Grassy Lake Rd west of Jack Pine St

ADA Grade Issue at existing crosswalk

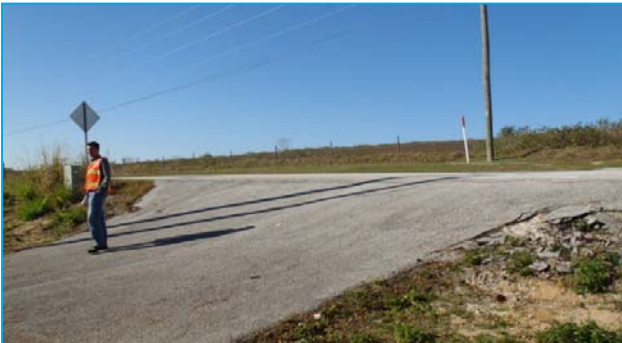
- ✓ Crosswalk facilitates shift of sidewalk from north side to south side of roadway
- ✓ Crosswalk connects to existing utilities access driveway with significant grade (does not meet ADA)
- ✓ Sidewalk connecting to driveway is covered with sand/debris
- ✓ Crosswalk does not have any lighting

- ✓ Shift midblock crosswalk further east (~200 ft) to avoid ADA/grade issue
- ✓ Add lighting so crosswalk is well lit and meets illumination standards
- ✓ Add advance yield lines (30 ft separation) & yield here to pedestrians signs
